Lead Local Flood Authority

RE: DC/26/0366 – Land North West of Southwater

WSSCC Lead Local Flood Authority previously provided comments on 2nd April 2026, with some requests for further information. [Updated LLFA comments can be seen in blue.](#)

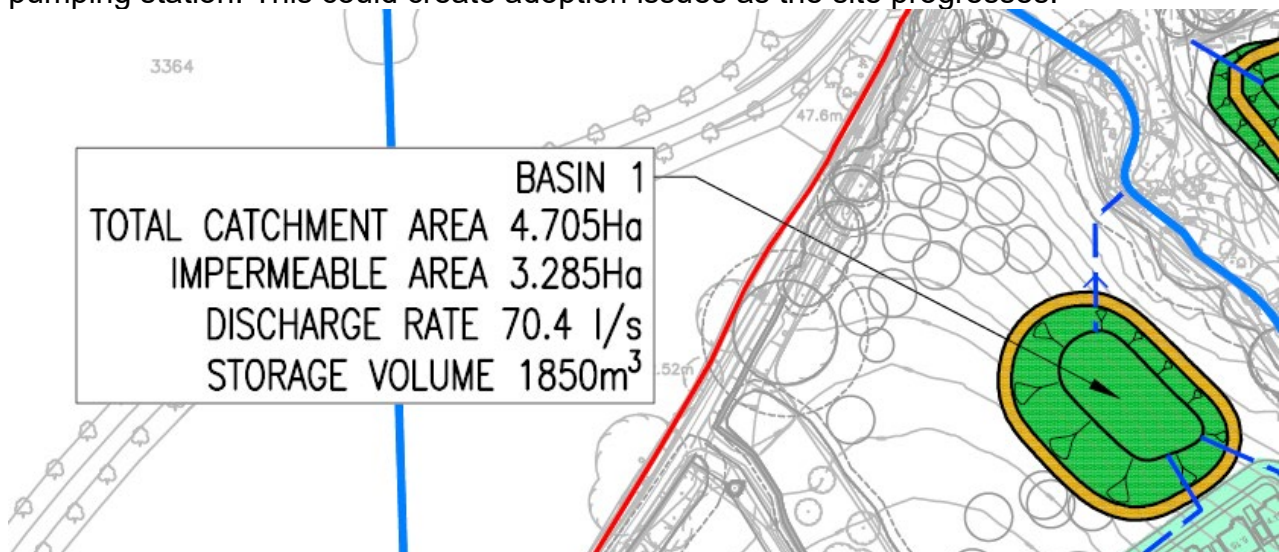
Although not a significant issue for outline planning applications, we disagree with some of the comments made in paragraph 8.2.2 in regard to non-potable use/rainwater harvesting. Higher cost is not a reason to disregard the use of rainwater harvesting. As West Sussex is seriously water stressed (this is very unlikely to change), greater consideration needs to be given to rainwater harvesting. This will also reduce water demand on the mains supply network. There are other developments which are residential which include rainwater harvesting.

We support suggestions to include rain gardens, bio retention areas and permeable paving within the residential parcels. For the school, we would also strongly encourage the use of source control SuDS features.

We will cover this via suitable conditions.

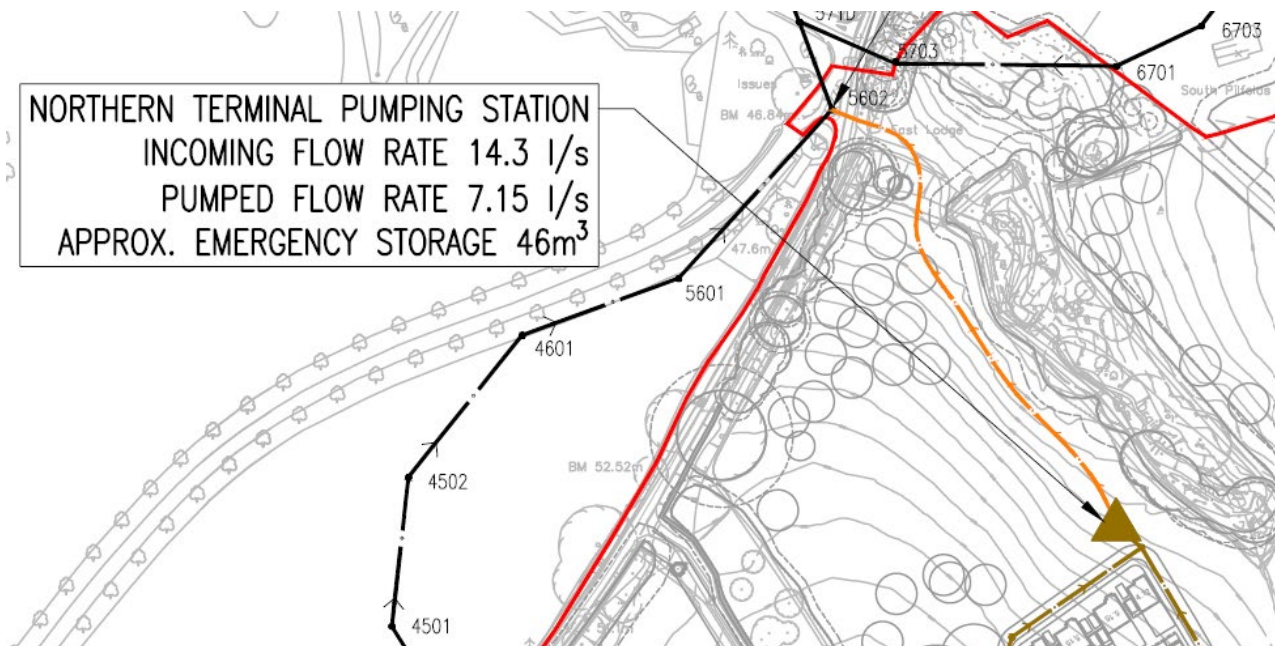
Within the underlying layout for the drainage strategy there are 'potential basins' – it is unclear what the function of these will be.

This is adequately addressed.

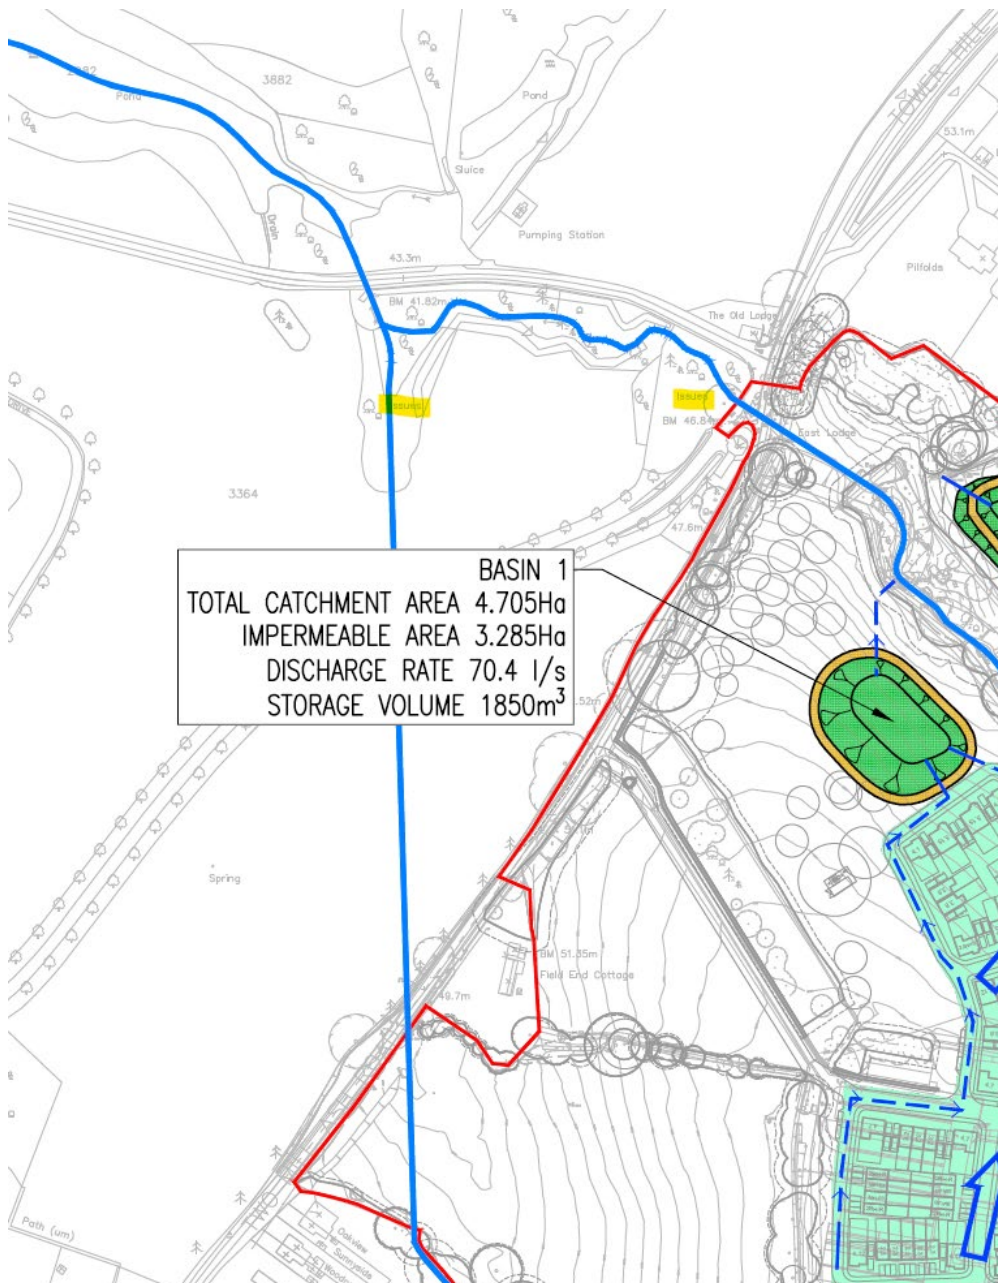
We would suggest that the watercourse lines on the drainage strategy may not be accurate. For example, it is very rare for a watercourse to be completely straight, unless it is underground as a culverted watercourse.

We would suggest altering the watercourse lines based on topographical and CCTV outputs, to better reflect the site's natural drainage.

Also related to watercourses, we have some concerns in relation to the topographical survey of the northern main watercourse, which has labels including: 'unable to locate headwall in this area due to flooding' 'evidence of broken pipe' and 'area flooded at time of survey'. The applicant is reminded that all watercourses within their land ownership must be maintained under the Land Drainage Act.

This is adequately addressed.
